Product Change Notification / BLAS-30BRVK558

CCB 6431 Initial Notice: Qualification of GTBF as an additional assembly site for selected CL1N8-G, CL25N8-G, CL2N8-G, FP0100N8-G, HV9921N8-G, HV9922N8-G, HV9923N8-G, LND150N8-G, LR645N8-G, LR745N8-G, LR8N8-G and MD0100N8-G catalog part numbers (CPN) available in 3L SOT-89 package.

Pre and Post Change Summary

PCN# BLAS-30BRVK558

LPI

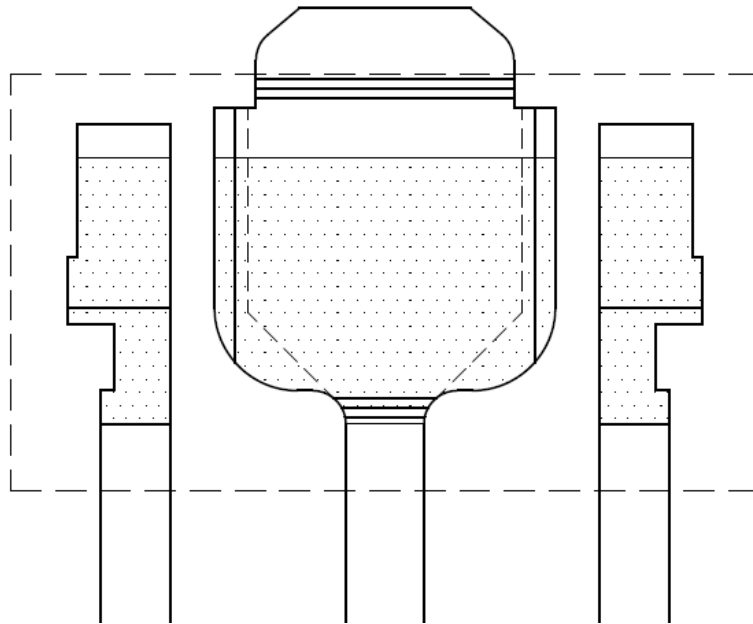
Lead frame Material	KFC
Lead-Frame Paddle Size	79x63mils

GTBF

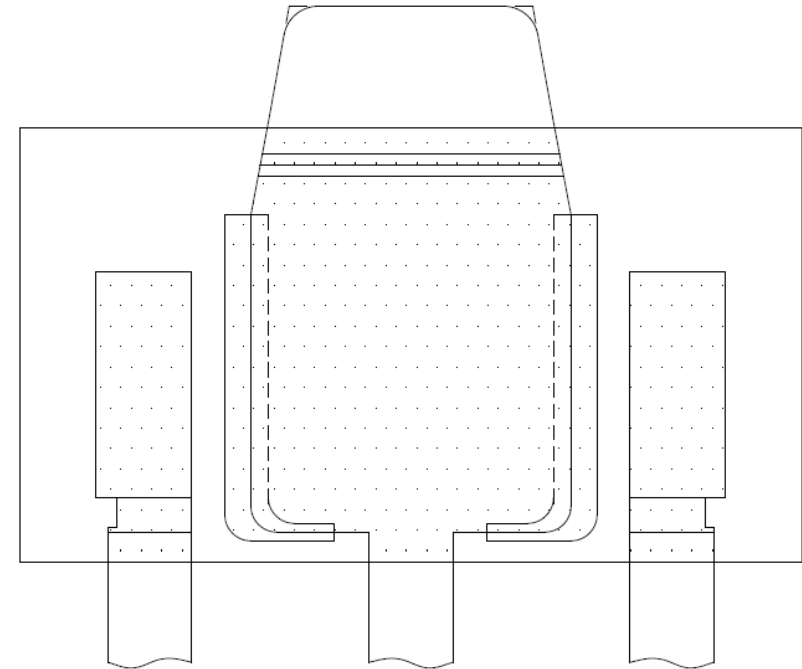
Lead frame Material	KFC/LY89
Lead-Frame Paddle Size	71x79mils
